M-720

(Revised October 14, 1977)

FRONT FENDER INSTALLATION / MX-250

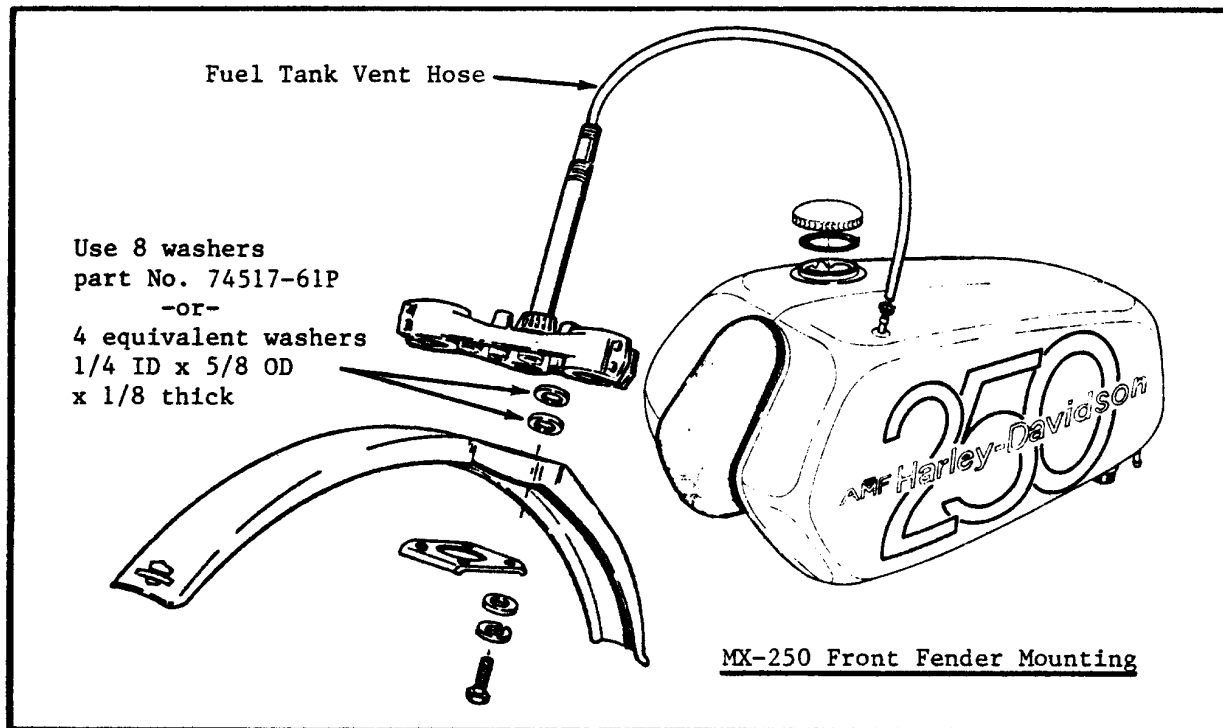
The MX-250 front fender installation requires spacing washers between the fender and front fork lower bracket to insure proper venting of the fuel tank vent hose through the fork stem. Do not drill fender as this hole could be plugged with mud.

Use eight washers part No. 74517-61P or four equivalent washers size 1/4 in. I.D. X 5/8 in. O.D. X 1/8 in. thick, located as shown in illustration below.
